## SERVICE BULLETIN

ENGINE - HP COMPRESSOR RING CASES - STAGES 7, 9 AND 10 INNER CASES- SPACERS AT HEAT SHIELD RETAINER ATTACHMENT POINTS WITH REDUCED SPIGOT LENGTH - CATEGORY CODE 6 - MOD.ENG-72-0182

V2500-ENG-72-0182

Section through HP compressor showing stage 7, 9 and 10 case assemblies - Before and after alteration  
Fig.2

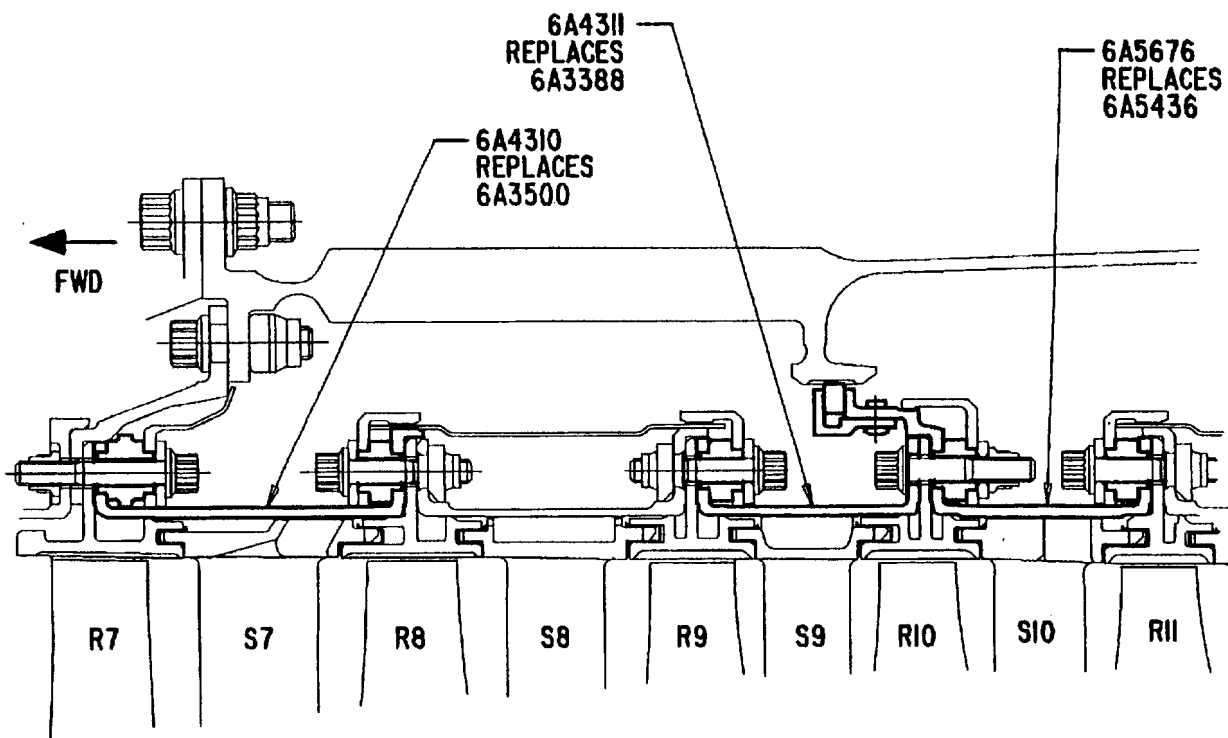
This Service Bulletin introduces stage 7, 9 and 10 rear inner case assemblies, incorporating spacers having a reduced spigot length. This ensures that a clearance will exist between the spacer spigot and washer when the bolts are tightened and will eliminate movement of the heat shield retainers.

Diagrammatic view on heat shield retaining half ring  
Fig.3

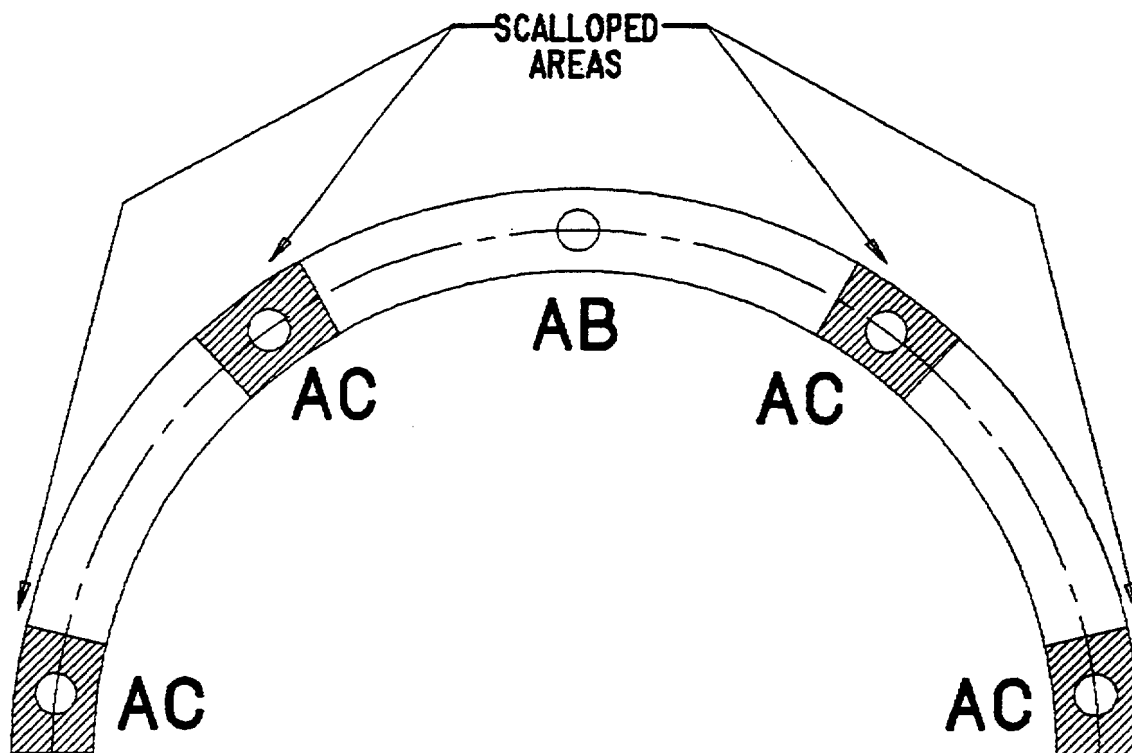
The heat shield retainers are half rings bolted to the inner casing flanges at 5 circumferential positions. The center position is firmly fixed but the spacer spigot length at the other 4 positions is such that firm clamping is not obtained. Thus allows the heat shield retainers to move relative to the spacers and washers and results in fretage.

**NOTE :- WITH SPACER (UPIII44) THE HALF-RING WAS FIRMLY LOCATED  
AT POSITION **AB** ONLY. AT POSITIONS MARKED **AC**  
THE SPACER SPIGOT EXTENDED THROUGH THE HALF-RING  
TO GIVE AXIAL RELIEF.  
WITH SPACER (UP60487) THE HALF-RING IS LOCATED  
FIRMLY AT ALL MOUNTING POSITIONS.**

Typical view showing build at AB - Before and after alteration  
Fig.4

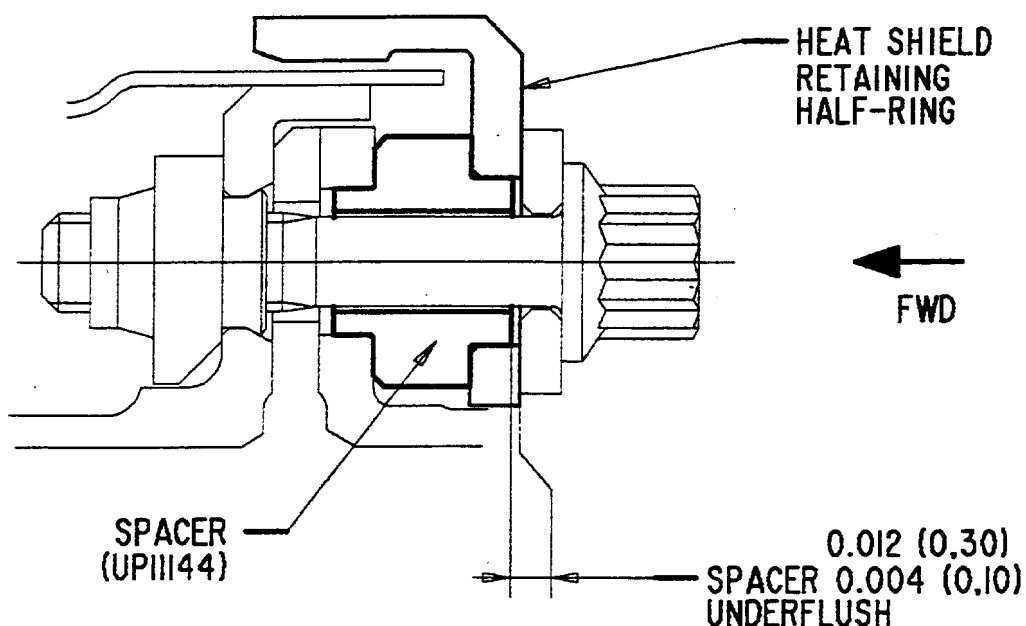
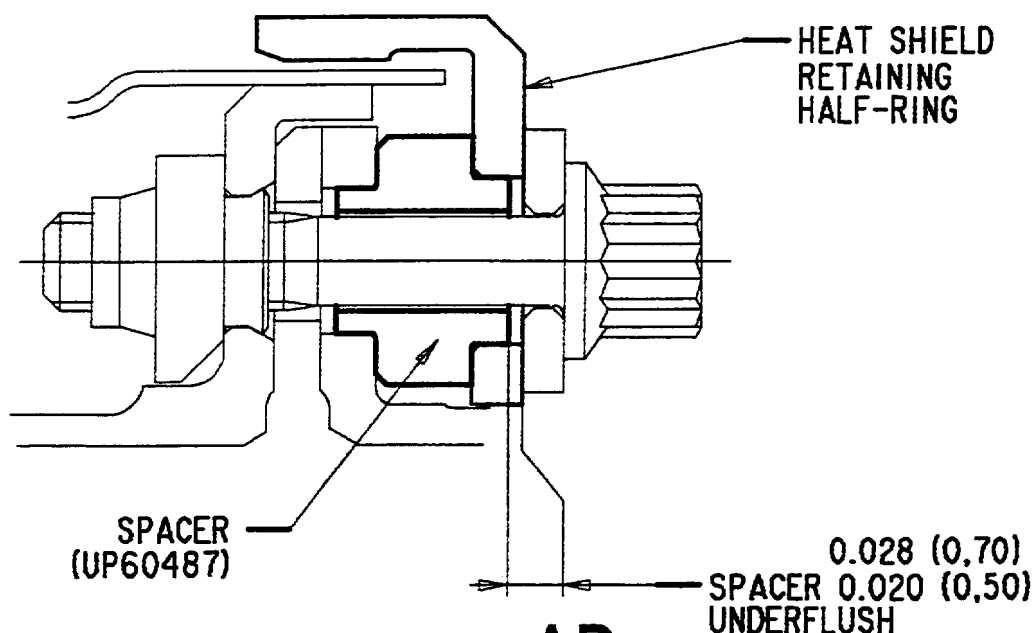
TYPICAL VIEW SHOWING BUILD AT **AB** BEFORE ALTERATION

TYPICAL VIEW SHOWING BUILD AT **AB** AFTER ALTERATION

REWORKING OF STAGE 10 REAR INNER COMPRESSOR CASE ASSEMBLIES  
ALL DIMENSIONS ARE IN INCHES (MILLIMETRES)Rework of stage 7, 9 and 10 rear inner compressor case assemblies  
Fig.6

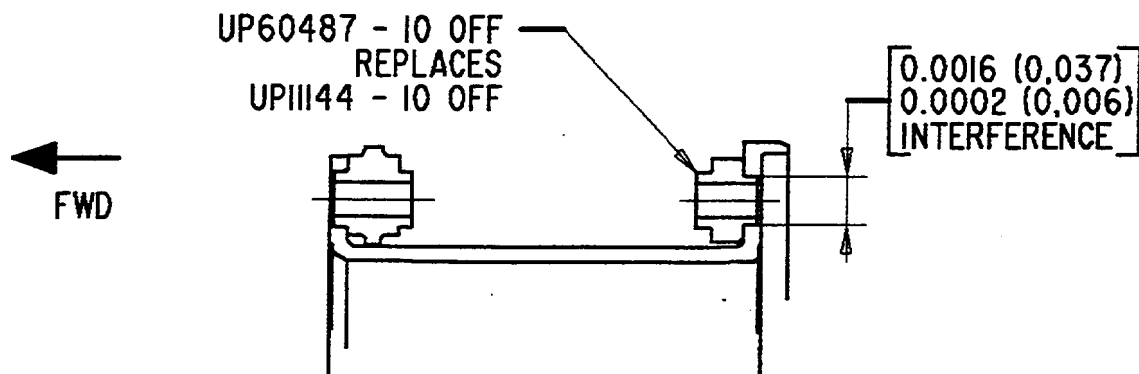
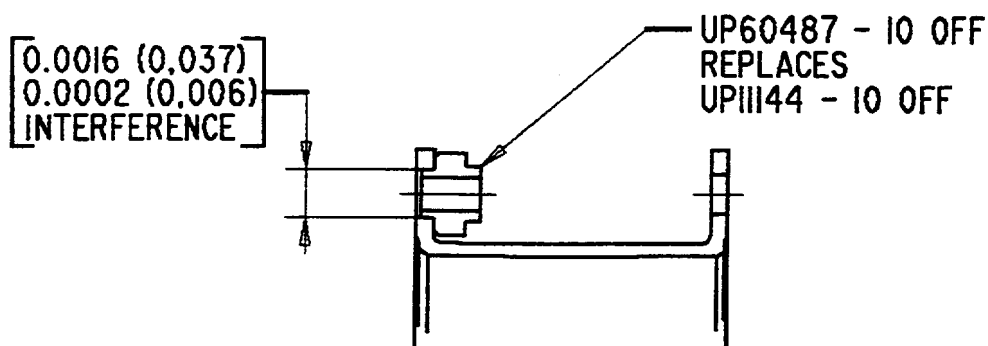
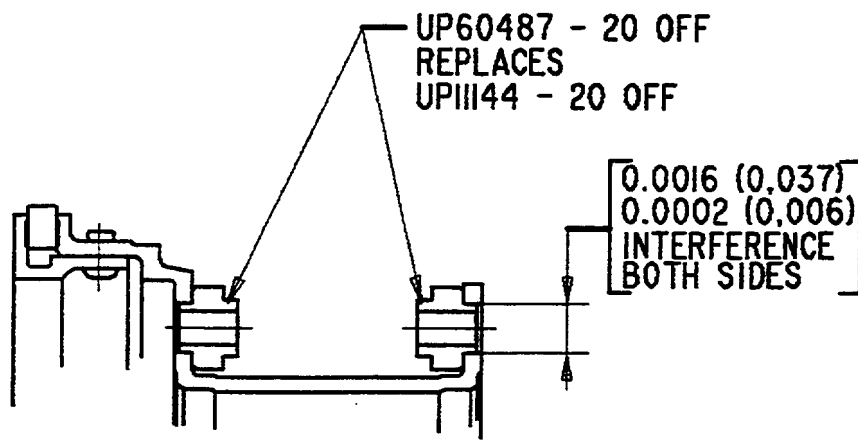
Procedure	Supplementary Information
(a) Remove the spacers	Refer to Figure 6 Use a drift or a locally made extractor.
(b) Remove the sharp edges front around the location holes	Refer to Figure 6 Use standard workshop equipment
(c) Clean the holes	Use a soft clean cloth
(d) Visually examine and measure the dimensions of the location holes	Refer to Figure 6 Examine the interference on the diameter. Reject if the location hole is oversize
(e) Crack test the affected area	Refer to SPM TASK 70-23-01-230-501 Use penetrant crack test equipment
(f) Freeze the spacers	Use UP60487 spacer-stage 7, (10 off), stage 9, (10 off) and stage 10, (20 off), case assembly. Use CoMat 03-026 liquid nitrogen

- (g) Install the spacers into the flange and make sure the spacers are pushed fully into position before the temperature of the spacer is equal to the flange
- Refer to Figure 6  
Use an applicable installation tool.  
Use heat protective gloves
